UNITED STATES PATENT AND TRADEMARK OFFICE

APPLICATION NO.	FILING DATE	FIRST NAMED INVENTOR	ATTORNEY DOCKET NO.	CONFIRMATION NO.
10/789,318	02/27/2004	Belgacem Haba	TESSERA 3.0-331	9218
38091	7590	06/30/2008	EXAMINER	
TESSERA			KALAM, ABUL	
LERNER DAVID et al.			ART UNIT	PAPER NUMBER
600 SOUTH AVENUE WEST				
WESTFIELD, NJ 07090			2814	
			MAIL DATE	DELIVERY MODE
			06/30/2008	PAPER

Office Action Summary	Application No.	Applicant(s)	
	10/789,318	HABA, BELGACEM	
	Examiner	Art Unit	
	Abul Kalam	2814

DETAILED ACTION

With respect to **claim 1**, **Suminoe** teaches a microelectronic assembly (**FIG. 8, illustrated below**), comprising:

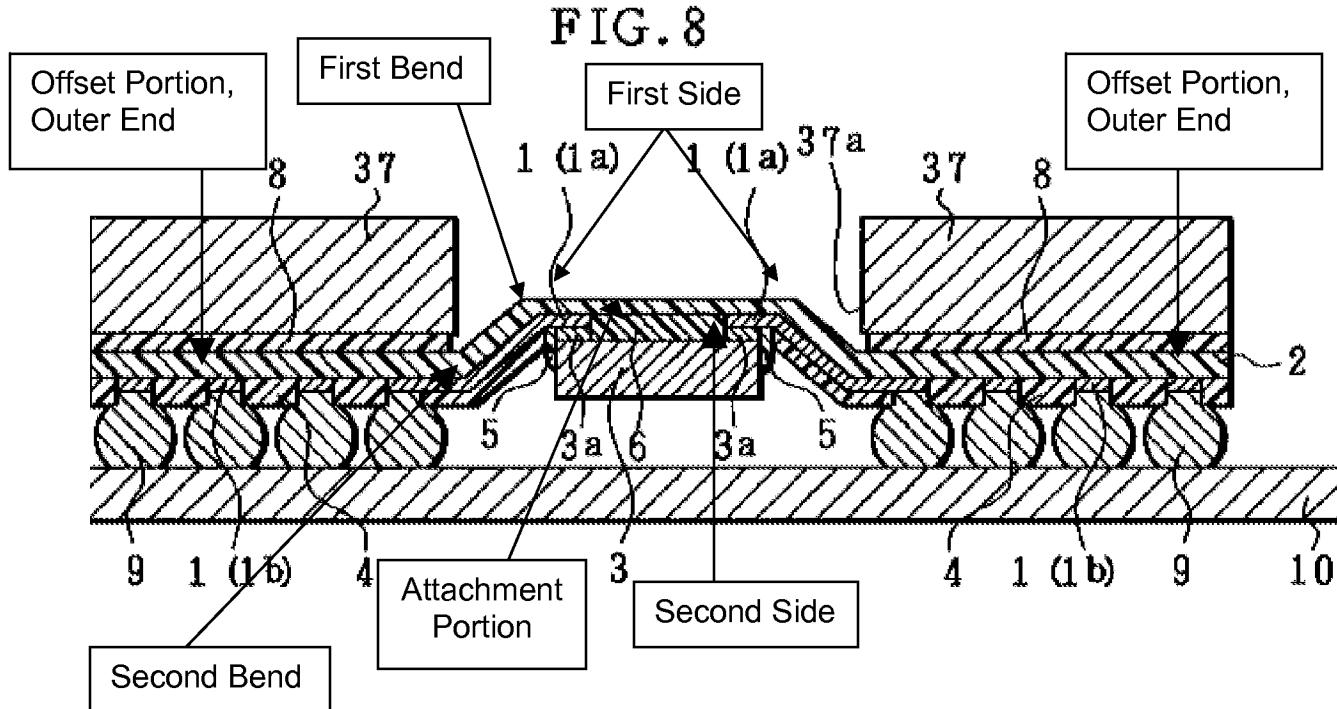
- a) a dielectric layer (**2**) having an attachment portion (**labeled in FIG. 8 below**), the dielectric layer (**2**) having a first side (**labeled in FIG. 8 below**) and an oppositely facing second side (**labeled in FIG. 8 below**), the first side of the dielectric layer in the attachment portion facing in a first direction, the second side of the dielectric layer in the attachment portion facing in a second direction, the dielectric layer having at least one offset portion (**labeled in FIG. 8 below**) offset from the attachment portion such that the offset portion is skewed in said second direction as compared to said attachment portion;

- b) a semiconductor chip (**3**) assembled to the second side of the dielectric layer in the attachment portion, wherein the first side of the dielectric layer (**2**) defines a boundary of the assembly such that the entire first side is unobstructed (**as shown in FIG. 8 below, the first side of the dielectric layer is exposed**); and

- c) terminal structures (**9**) carried by the offset portion of the dielectric layer (**2**) for connecting the semiconductor chip (**3**) with external circuitry (**10**) lying at a lower level than the attachment portion (**col. 8: Ins. 39-65; col. 14: Ins. 1-30**).

With respect to **claim 2**, **Suminoe** teaches the assembly of claim 1 as set forth above, wherein the attachment portion (**labeled in FIG. 8 above**) of the dielectric layer (**2**) is substantially planar.

With respect to **claim 3**, **Suminoe** teaches the assembly of claim 1 as set forth above, wherein the dielectric layer (**2**) has at least one bend (**col. 14: Ins. 12-14**) between the attachment portion (**labeled in FIG. 8 above**) and the offset portion (**labeled in FIG. 8 above**).

With respect to **claim 4**, **Suminoe** teaches the assembly of claim 3 as set forth above, wherein the at least one bend comprises a first bend in the third direction and a second bend (**labeled in FIG. 8 above**) in fourth direction opposite to the third direction.

With respect to **claim 5, Suminoe** teaches the assembly of claims 4 as set forth above, wherein the dielectric layer **(2)** has at least one conductor **(1a, 1b)** extending in the bend **(FIG. 8).**

- a) a dielectric layer **(2)** having an attachment portion (**labeled in FIG. 8 above**), the dielectric layer having a first side, a second side, and outer ends (**all labeled in FIG. 8 above**) lying outwardly of the attachment portion, the outer ends being offset from the attachment portion;
- b) a semiconductor chip **(3)** assembled to the second side of the dielectric layer **(2)** at the attachment portion; the entire first side (**labeled in FIG. 8 above**) of the dielectric layer being unobstructed; and
- c) terminal structures **(9)** carried by the outer ends of the dielectric layer **(2)** for connecting the semiconductor chip **(3)** with external circuitry **(10)** (**FIG. 8, as illustrated above; col. 8: Ins. 39-65; col. 14: Ins. 1-30**).

Applicant argues that "Suminoe fails to teach that a side of the dielectric layer defines a boundary of the assembly such that the entire first side of the dielectric layer is unobstructed, as required by independent Claims 1 and 25." The argument is not persuasive because the top most side (labeled "first side" in FIG. 8 above) of the dielectric layer **2** reads on Applicant's claimed limitations. Thus, the top most side of the dielectric layer **2** defines a boundary of the assembly such that the entire top most side of the dielectric layer **2** is unobstructed. Note that only the top most side of the dielectric layer **2** is interpreted as the first side of the dielectric layer.
